ALTITUDE HOTEL & RESIDENCES

Downtown DRB
Design Recommendation Meeting No. 1

DPD# 3018037
August 16, 2016

FORM - IMPROVEMENTS FROM PREVIOUS DESIGN

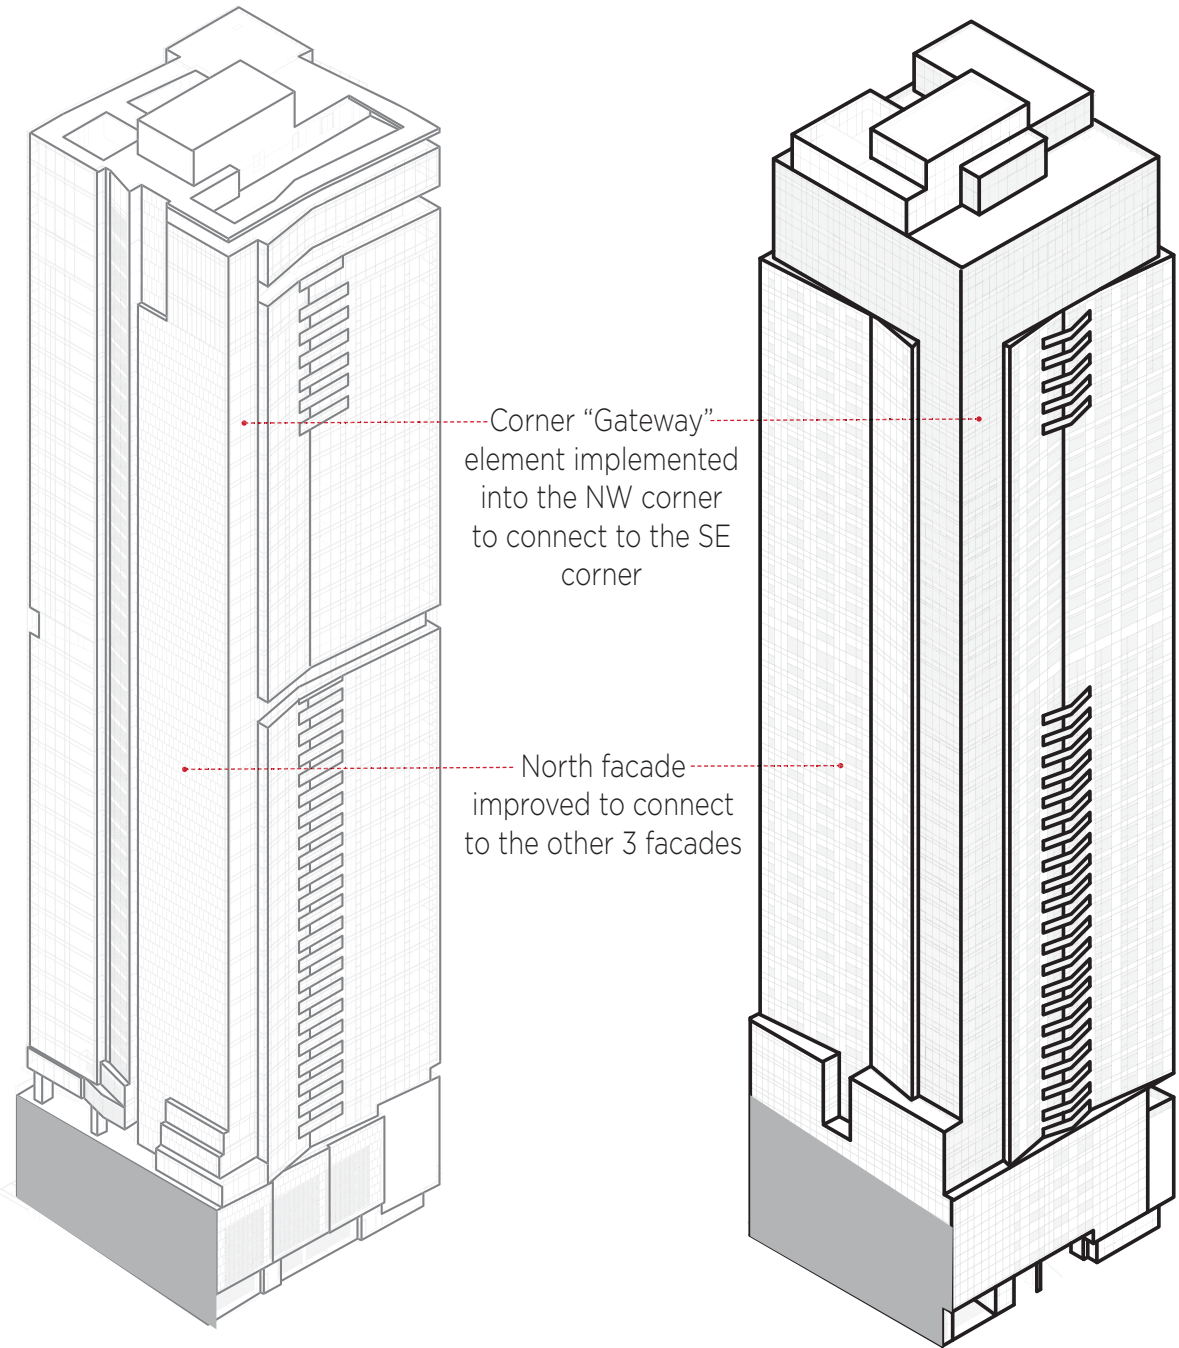
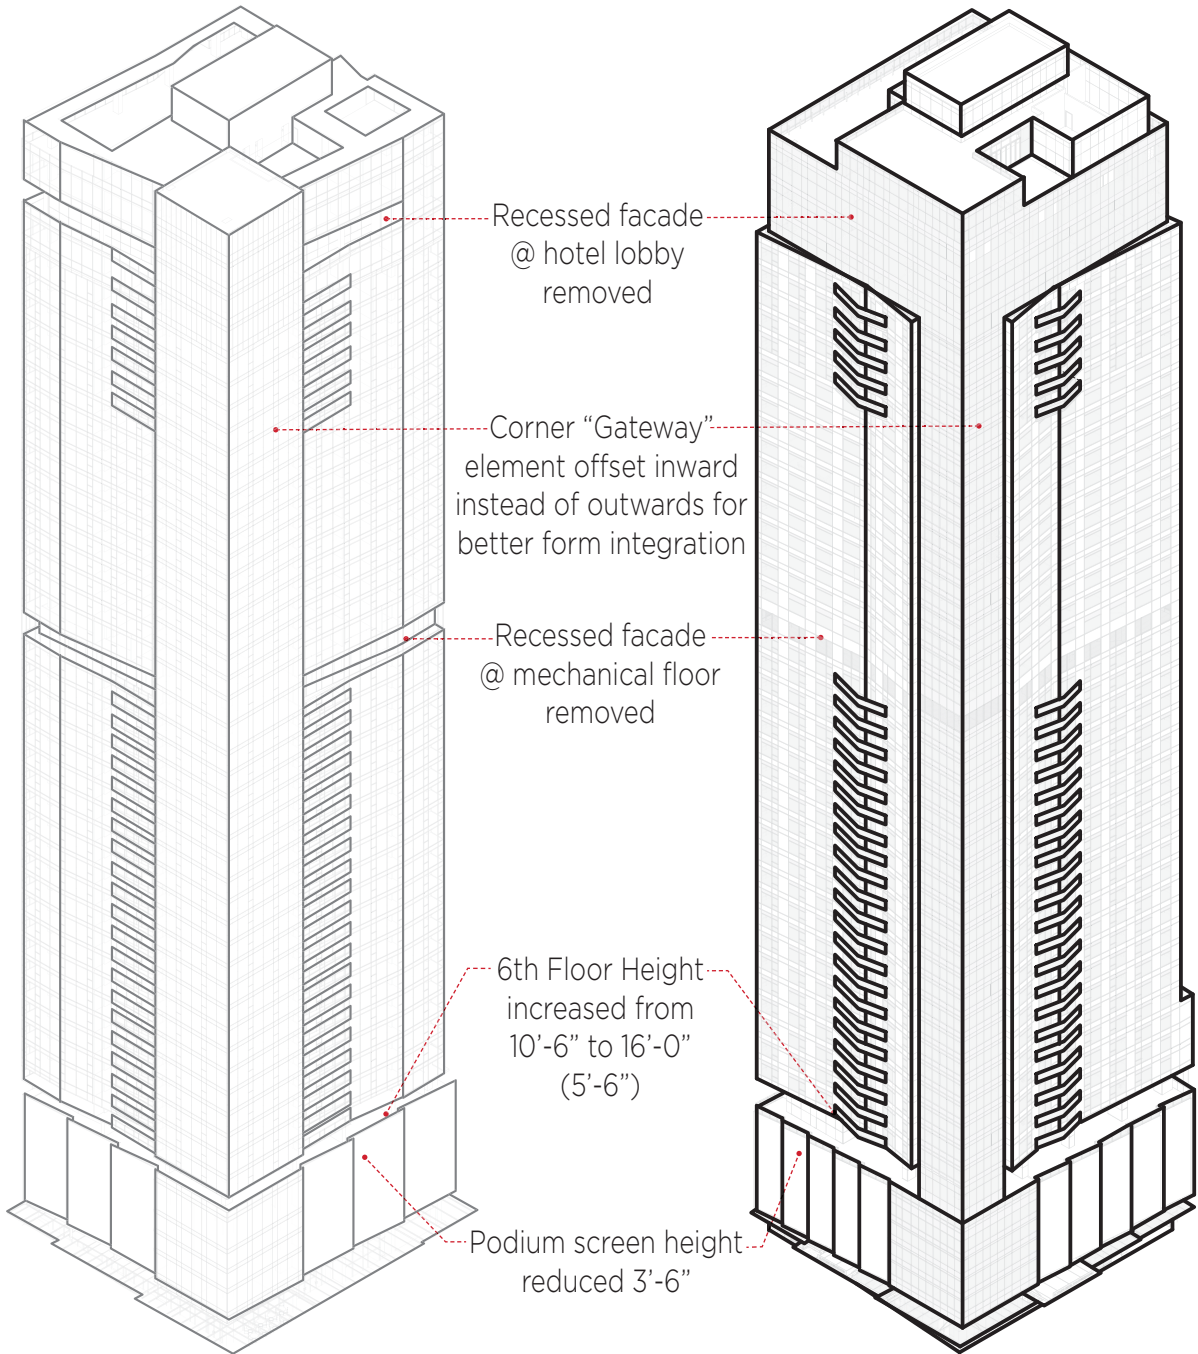
- EDG3 - #1 *The podium screen should be reduced in height & the overall size of the panels should be reduced to relate more comfortably to the pedestrian scale*
- EDG3 - #2 *The height of the 6th floor amenity area should be increased*
- EDG3 - #3 *The recess of the mechanical level at the 31st floor detracts from the integration and gracious flow of the tower & should be eliminated*

The overall form was modified to provide a uniform design logic that would be consistently apparent across all four facades while maintaining the general design & program objectives

MATERIAL ANALYSIS - SOUTHEAST CORNER

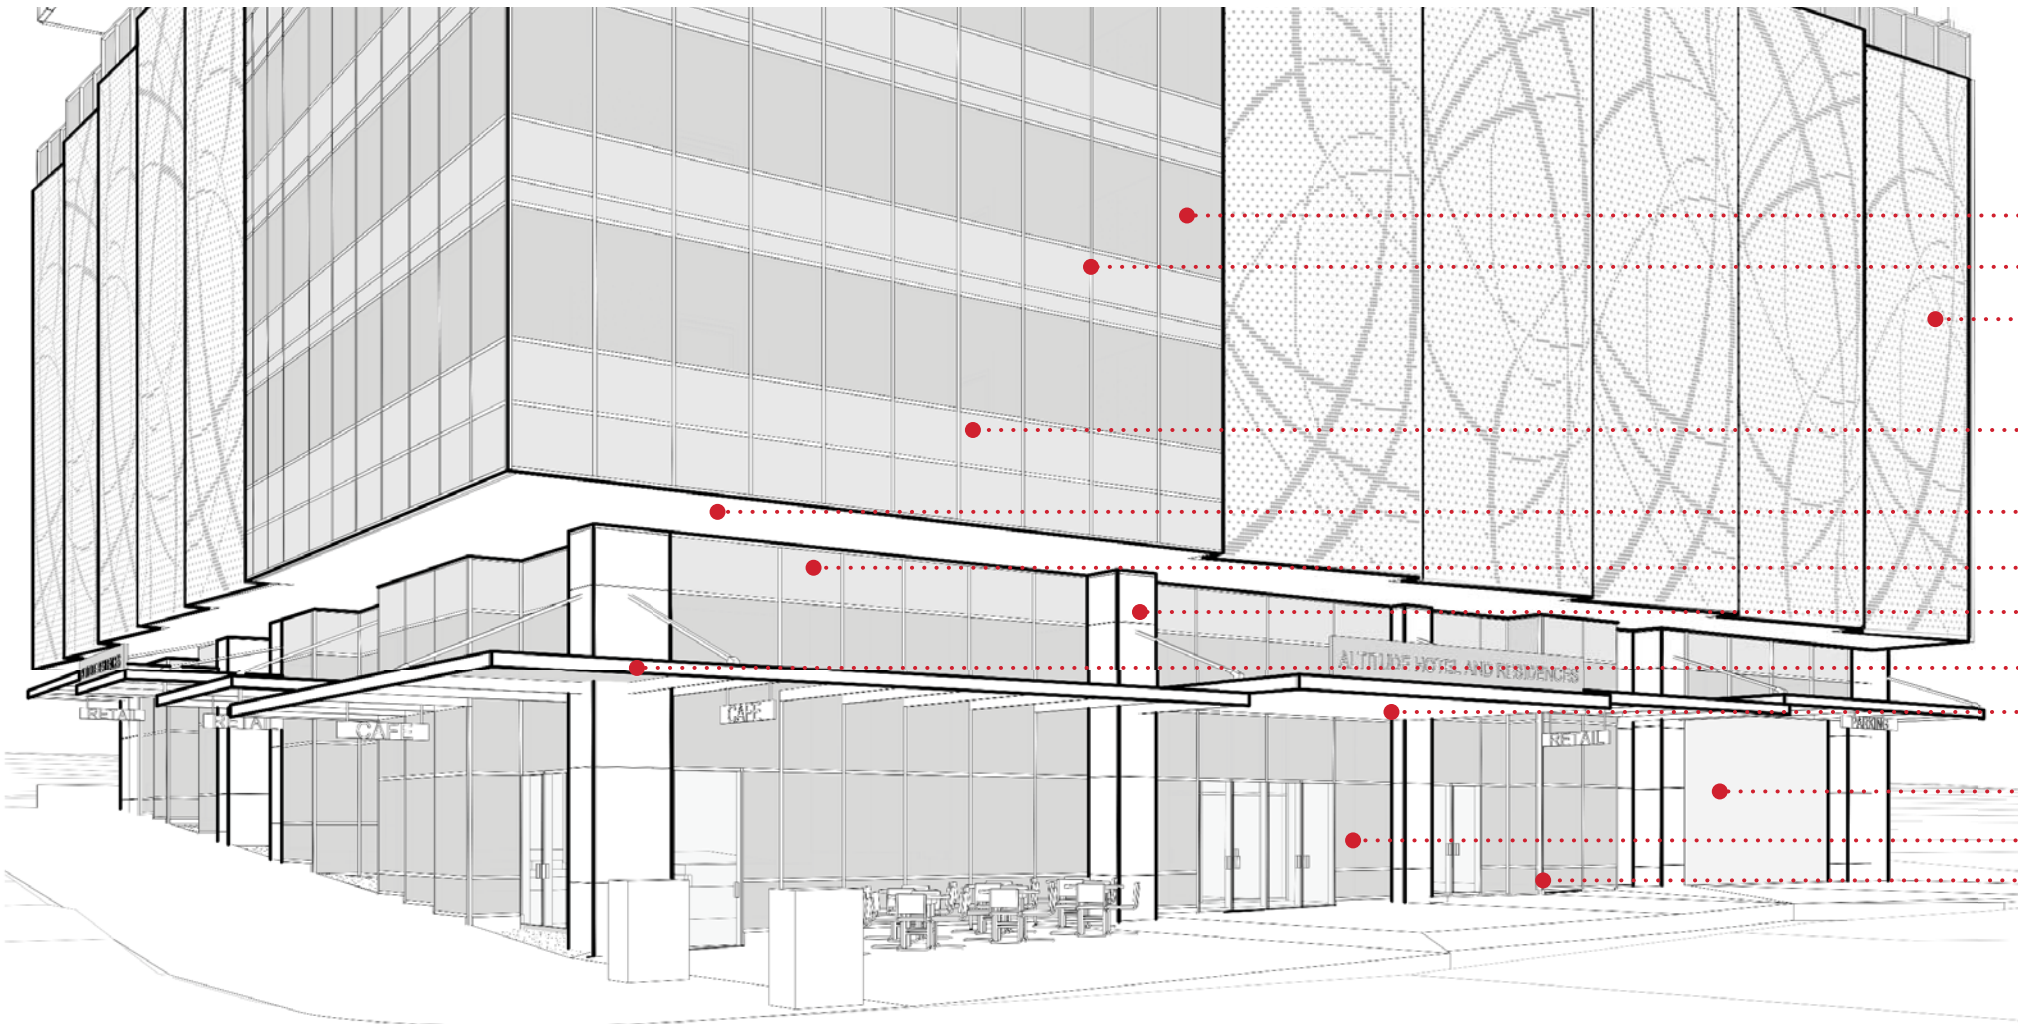
- COMMENTS ADDRESSED:
LU - #4 Provide perspectives that clearly delineate the precision on the faceted edge where the south and east facades meet at various levels of the proposed structure
- Vision Glass: Material "F"
 - Mullion: Material "B"
 - Decorative Art Screen: Material "D"
 - Glass Spandrel Panel: Material "E"
 - Wood Ceiling
 - Glass Spandrel Panel: Material "E"
 - Metal Panel: Material "A"
 - Aluminum & Glass Canopies
 - Wood Ceiling, Hotel & Residential Entry Only
 - Security Grille
 - Vision Glass: Material "F"
 - Mullion: Material "B"

ROOFTOP

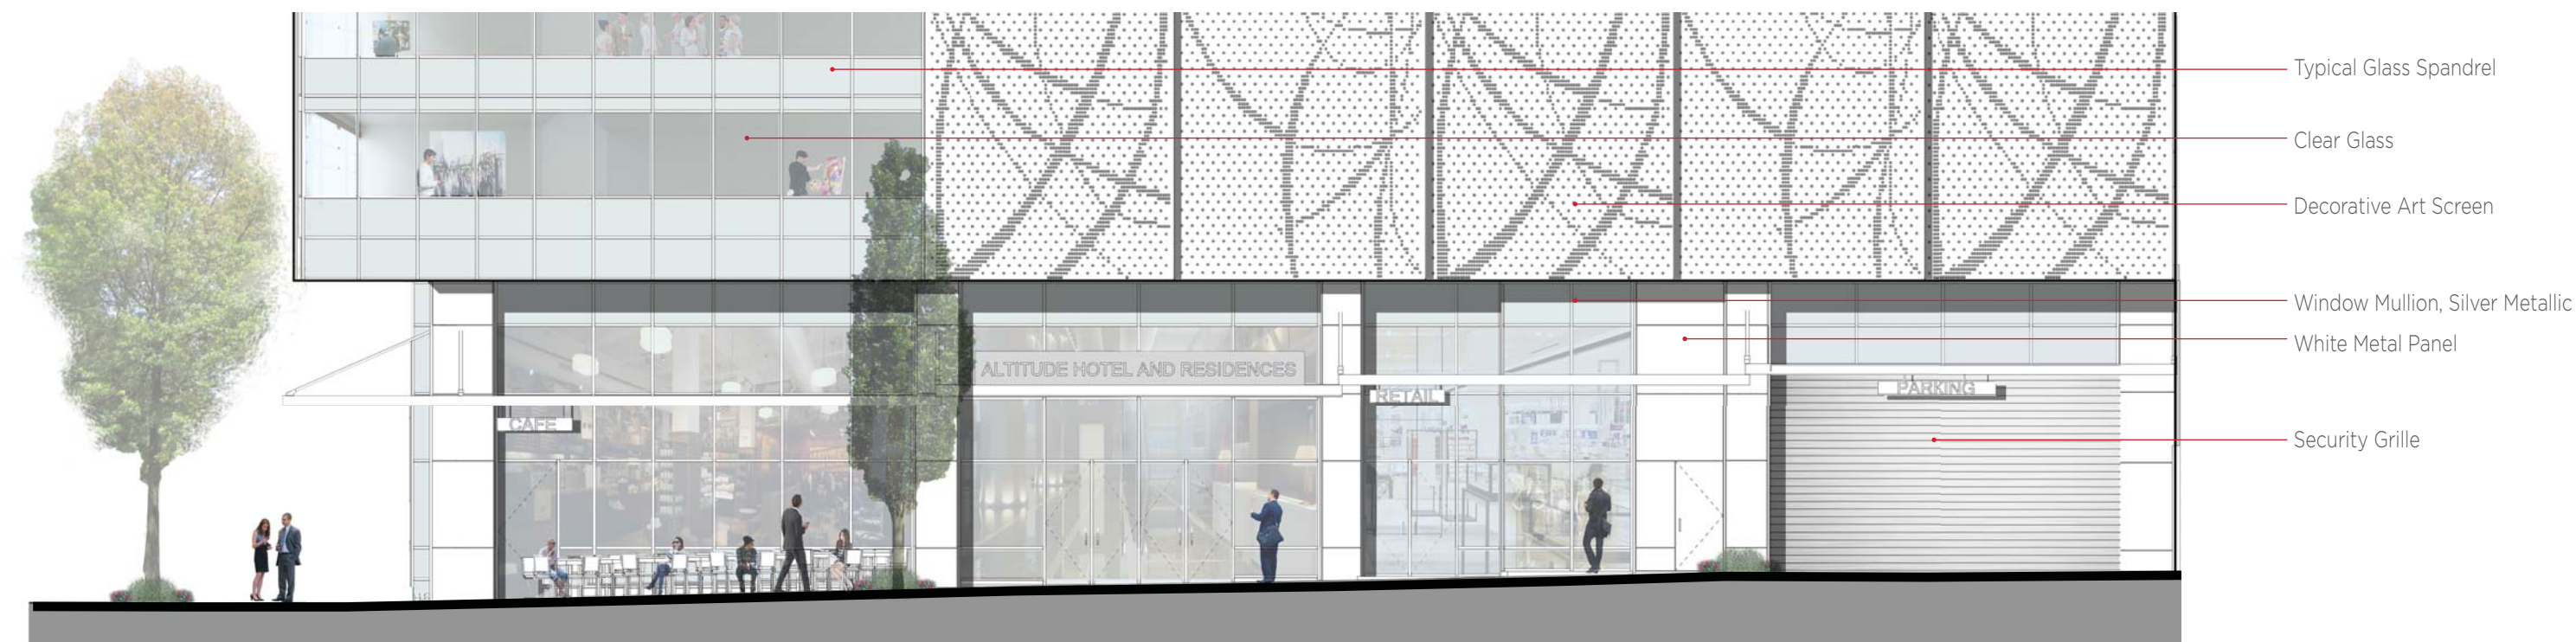
COMMENTS ADDRESSED:
EDG3 - #6 *The termination of the tower needs to be more thoughtfully resolved*

PODIUM ANALYSIS - PROGRESS FROM EDG #3

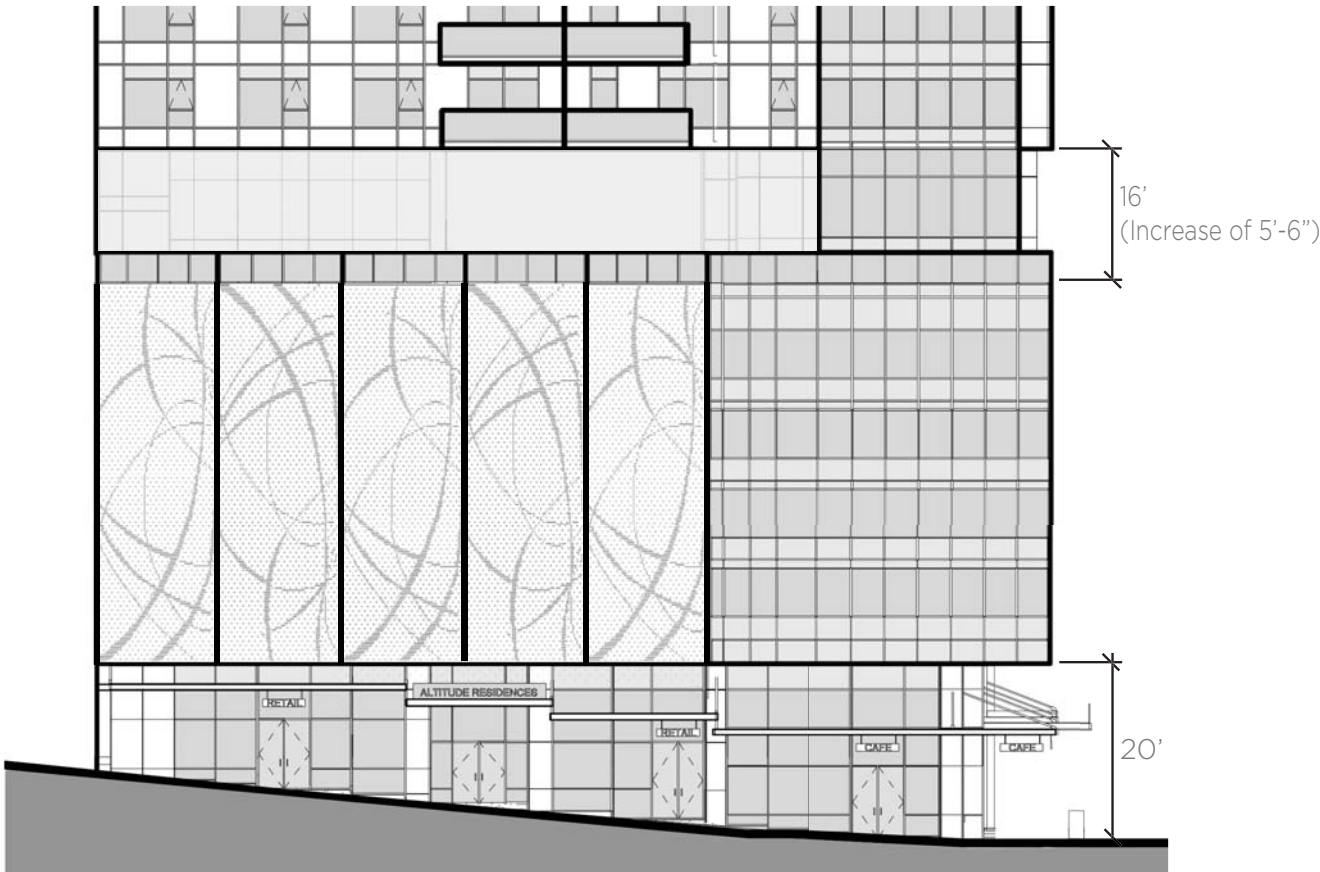
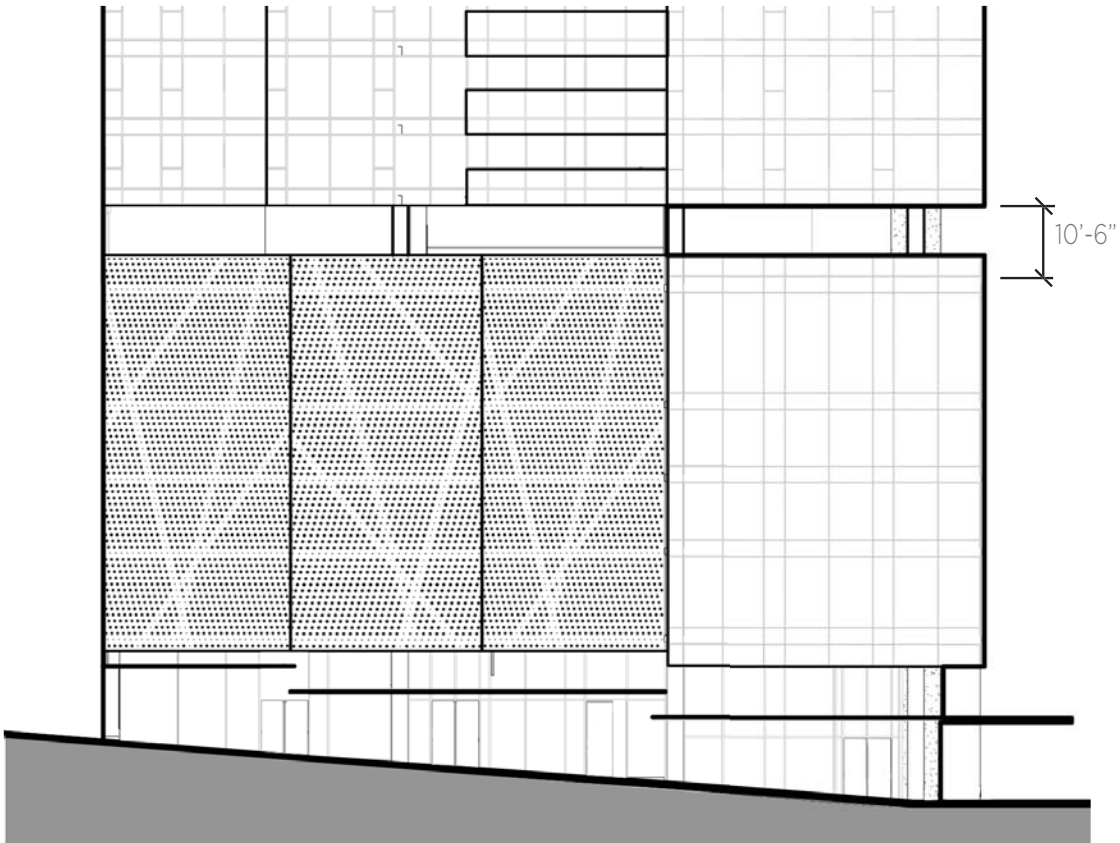
EDG3 - #1 *The podium screen should be reduced in height & the overall size of the panels should be reduced to relate more comfortably to the pedestrian scale*

EDG3 - #2 *The height of the 6th floor amenity area should be increased*
